REVIEW of the NAVY LINES OF EVIDENCE for GROUNDWATER FLOW: CSM Section 6.8

GROUNDWATER FLOW

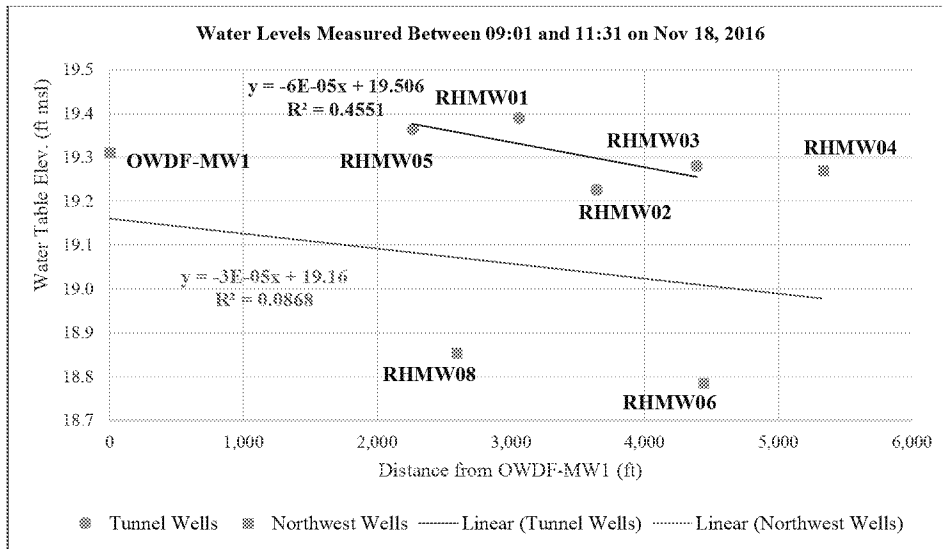
- a) *The 18 Nov., 2016 synoptic water level survey shows a weak gradient in the opposite direction of what the Navy is stating in this LOE. Ignoring wells RHMW07 (due the significantly elevated groundwater elevation) and RHMW01 (since RHMW01 is a 1" well with no gyroscopic correction), and HDMW2253-03. Separate regressions done on the tunnel wells and the northwest boundary wells show a gradient of about 5×10^{-5} ft/mi dipping up the ridge (that is from OWDF-MW1 toward RHMW04). The November, 2016 synoptic water level survey definitely does not support regional flow down the Red Hill Ridges. Refer to Figure 1.*

Figure 2. The proportional chemical distribution of the major dissolved ions as reported by AECOM at the November SME meeting. The Navy is contending that the Piper Diagrams show that groundwater is flowing from RHMW02&03 to OWDF-MW1.

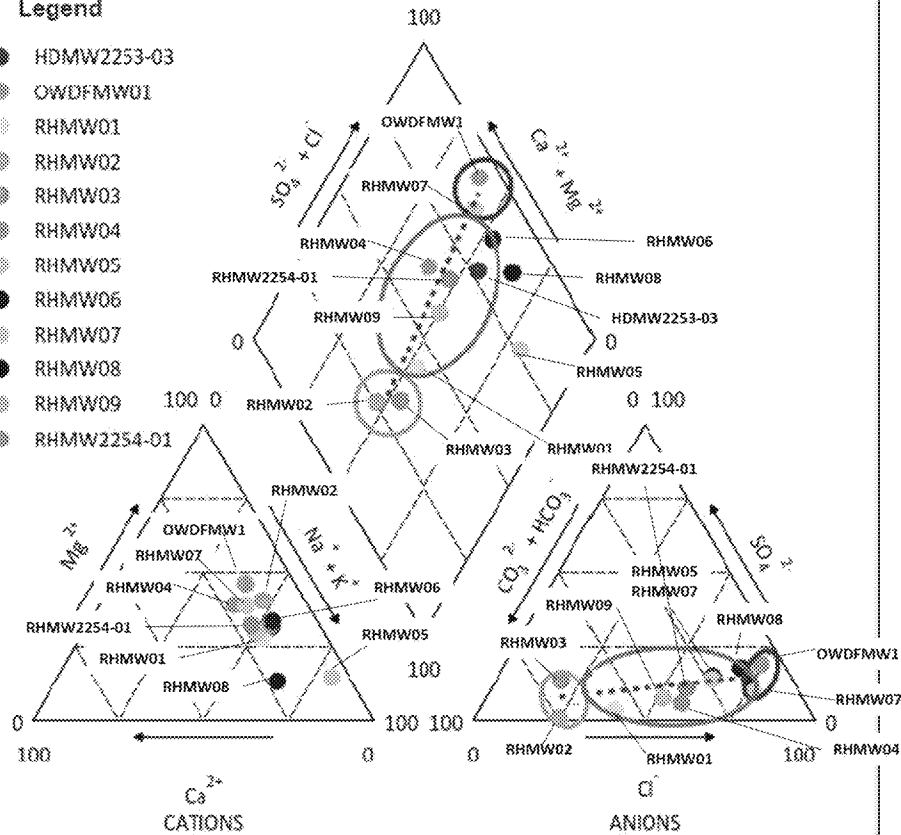
- d) *This LOE relies on the mixing implied by the Piper Diagram in Figure 6-31. There appears to be a misunderstanding on the Navy's part on how to interpret Piper Diagrams. While it is true that one of the uses of a Piper Diagram is to assess mixing trends, this assumes conservative mixing. That is, no chemical alteration of the water occurs along the flow path between the end members. The Navy's interpretation of the Piper Diagrams is heavily dependent on the anions. A Piper Diagram considers three anions; bicarbonate, chloride, and sulfate. The proportions of bicarbonate and sulfate are altered due to the natural attenuation processes making anions ~~an~~ an invalid candidate for mixing analysis ~~and~~ since the alteration violates the assumption of conservative mixing.*

- g) *When the Piper Diagram inferred flow and mixing paths are mapped, no logical travel path results (see Figure 2 and 3). From Dever (1997) Appendix I Page 411 "Conversely, if the water compositions do not plot along straight lines in each of the fields their compositions are not controlled by simple mixing." It seems while informative conclusions can come from scrutiny of the Piper Diagrams, groundwater flow paths is not one of them.*

Figure 4. The Conductivity-Temperature-Depth profile of the HDMW2254-03 Well shows that the denser-brackish water flows up from -700 ft msl within the well bore then exits at -100 ft msl, significantly below the elevations of the RHMW06&07 well screens.

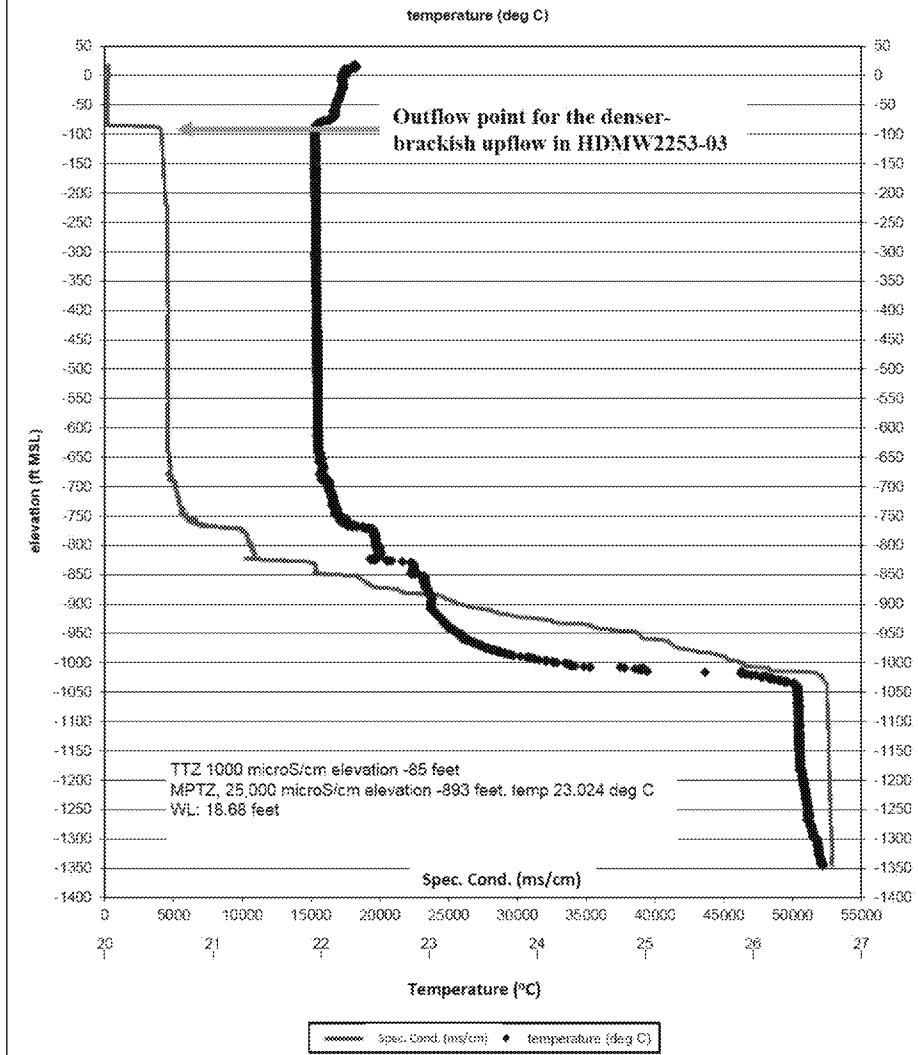
b) The Navy contends that one of the sources of sodium-chloride type water is groundwater flowing up the well bore of HDWM2253-03. For this line of evidence to be credible, a process needs to be identified where denser water that enters the aquifer at -100 ft msl rises into the well screens of OWDF-MW1, and RHMW06 & 07 (at elevations of X ft msl...) after passing through or under the saprolite. (see HDMW2253-03 conductivity-temperature-depth profile, Figure 4).

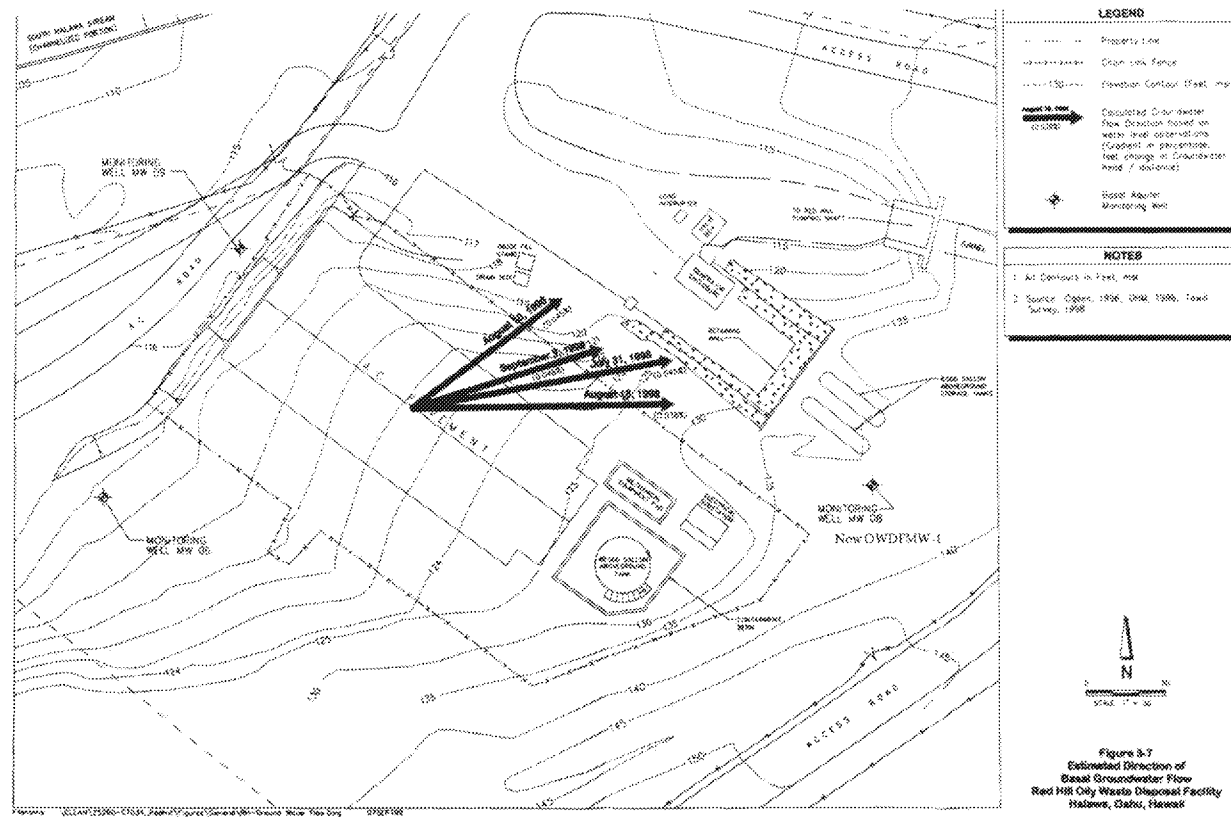
- c) *The wide variability in groundwater chemistry and the flat gradient could be more easily explained by much less groundwater flowing beneath the Red Hill Facility. Much lower inputs of chemically contrasting groundwater would be required to attain the span of chemistry we observe. Regarding the elevated salinity in RHMW06&07, it is interesting to note that in the 2000 investigation of the Oily Waste Disposal Basin a groundwater flow direction was measured from OWDB wells toward RHMW06&07 (see Figure 5). High salinity was measured in two out of three basal wells installed in the OWDB providing a source of salts to RHMW07 & 06. It seems this flow path is easier to reconcile with the available data than that proposed by the Navy.*
